DEVELOPMENT DETERMINATION PANEL MEETING

WEDNESDAY 3 MAY 2023

**Agenda for a Meeting of the Development Determination Panel
to be held on Wednesday 3 May 2023
via teleconference
Commencing at 10:00am**

3.1	DA2022/1610 - 35 Bushey Place DEE WHY - Alterations and additions to a dwelling house.....	5
3.2	DA2022/1694 - 995 Barrenjoey Road PALM BEACH - Alterations and additions to a dwelling house	50

Figure 3 - Marked up plan (by assessing officer) showing the 8.5m and 10m building height through Section C using the 'Bettar' extrapolated ground level method of measurement.

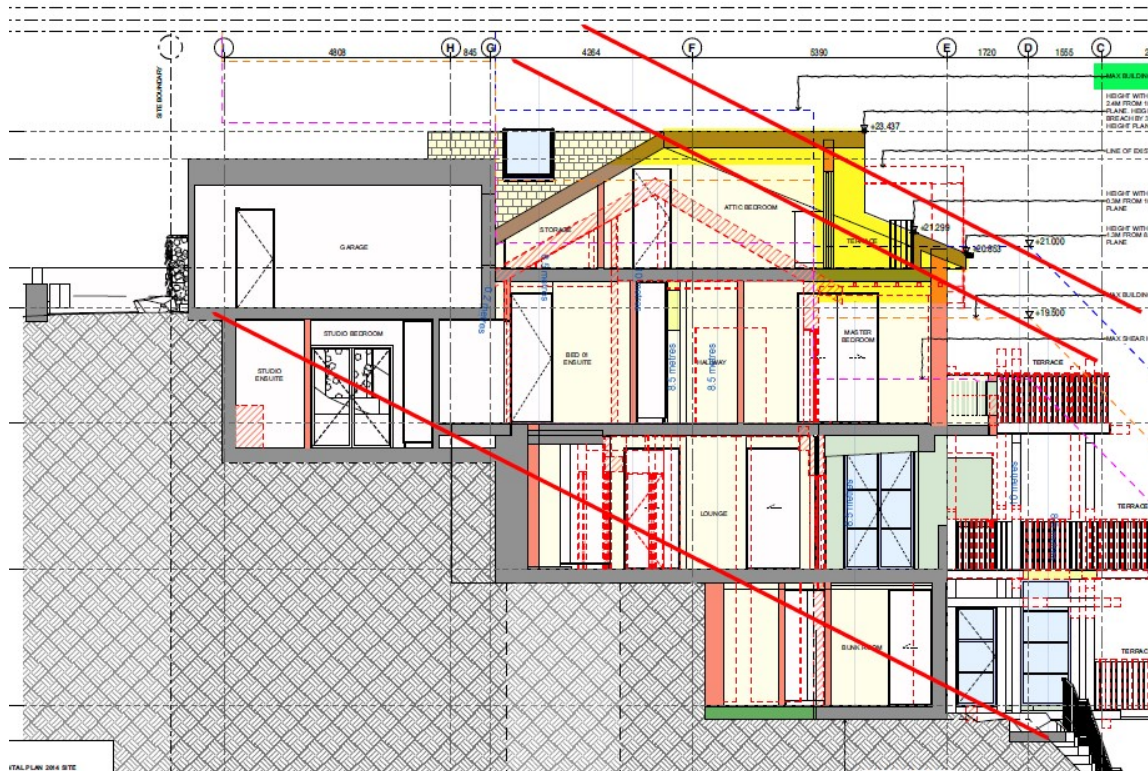
It is not agreed that the additional height will be sympathetic to the surrounding natural environment. The additional height will make it more difficult for the building to sit below the tree canopy and be integrated into the natural environment as viewed from the waterway. The statement that the proposal is consistent with the provisions of the DCP is also not agreed, noting the extent of non-compliant building envelope at the northern facade, reduction in landscape area and inconsistency with the Desired Future Character statement, which envisages a residential character comprising of two storey dwellings.

Therefore, the applicant's written request has not adequately demonstrated that there are sufficient environmental planning grounds to justify contravening the development standard as required by cl 4.6 (3)(b).

Figure 1 - Southern Side of building - Area marked red non-compliant.

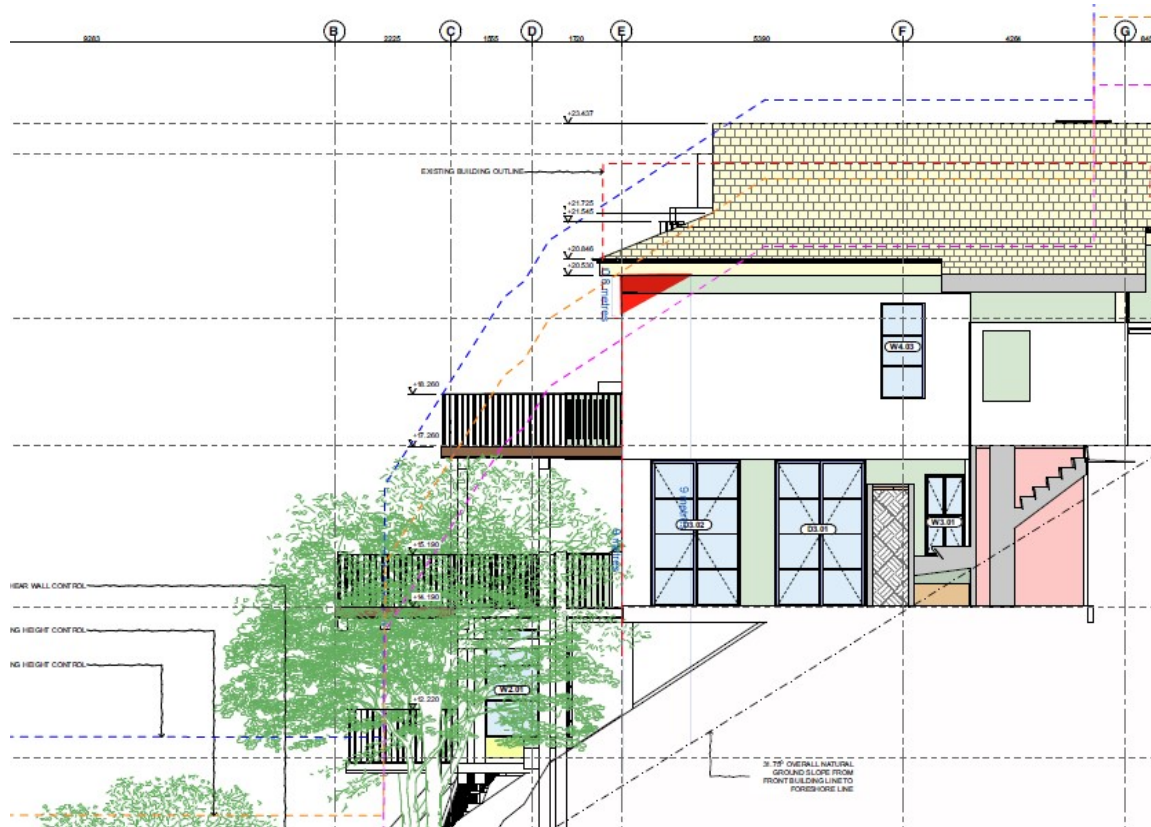
The proposal has an encroachment of the southern side boundary building envelope (Figure 1 below). The dwelling facade on the northern side encroaches to a greater extent (figure 2 below).

Image: Height line using 8.5 and 10m height line along natural ground level.

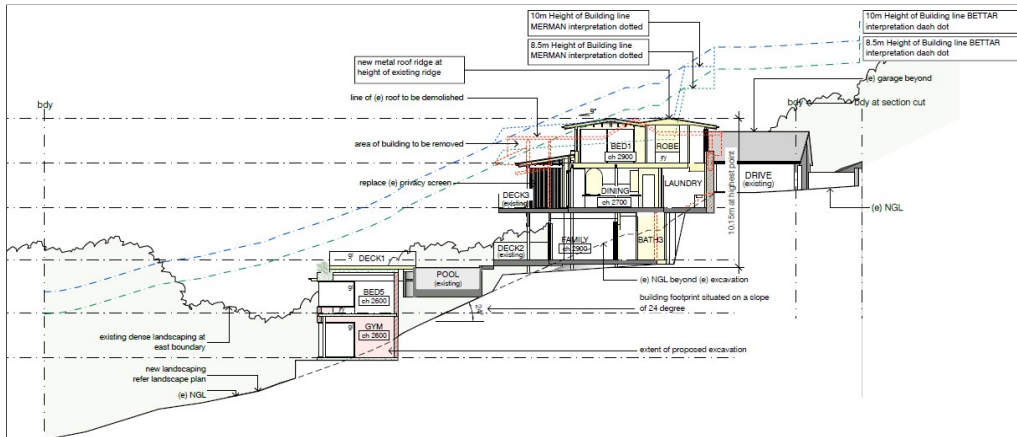
Note: Non-compliant element occurs at the excavated section below the existing ground level. Height is measured pursuant to the approach taken in *Merman Investments Pty Ltd v Woollahra Municipal Council [2021] NSWLEC 1582* the existing excavated ground level measured as per the architectural sections.

The diagram also demonstrates the building height as measured by the alternate method used in *Bettar v Council of City of Sydney* [2014] NSWLEC 1070 in which the building is 8.8m (2.5%) above extrapolated ground level.

Image: Front boundary line and plan view including existing approved structures and new work (ground level).

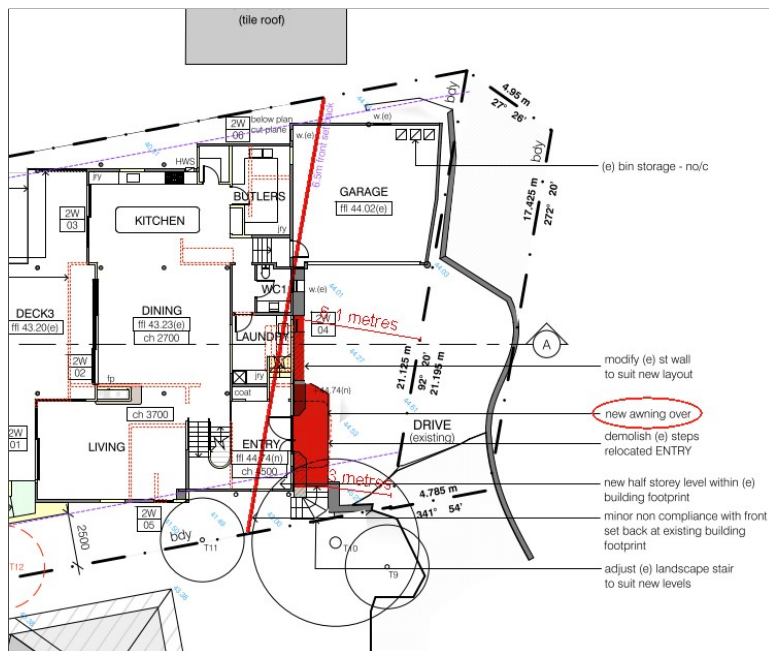
The non-compliant element at Level 2 comprises a new awning over the entry and an addition to an existing wall, as detailed below in red:

Image: Front boundary line and plan view including existing approved structures and new work (Upper level).

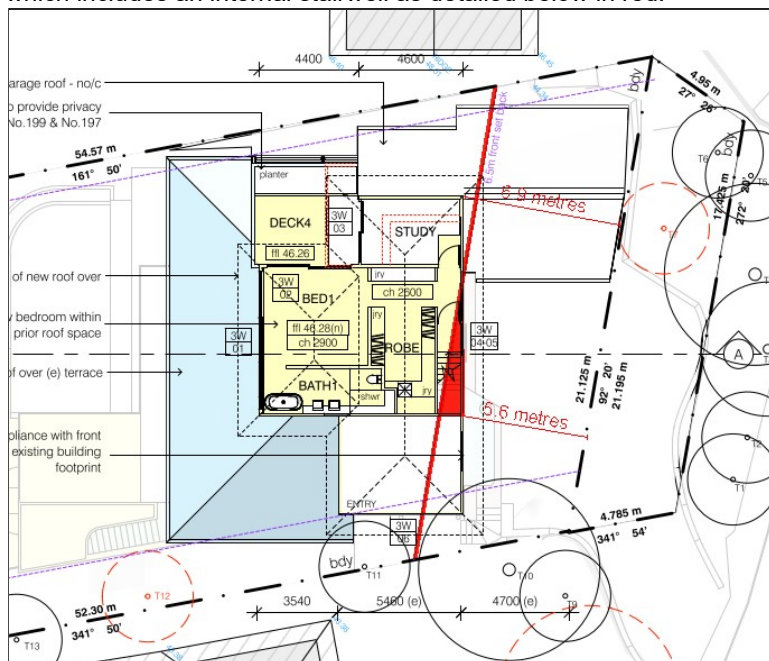
The non-compliant element at Level 3 comprises the south-western corner of the new upper floor level which includes an internal stairwell as detailed below in red:
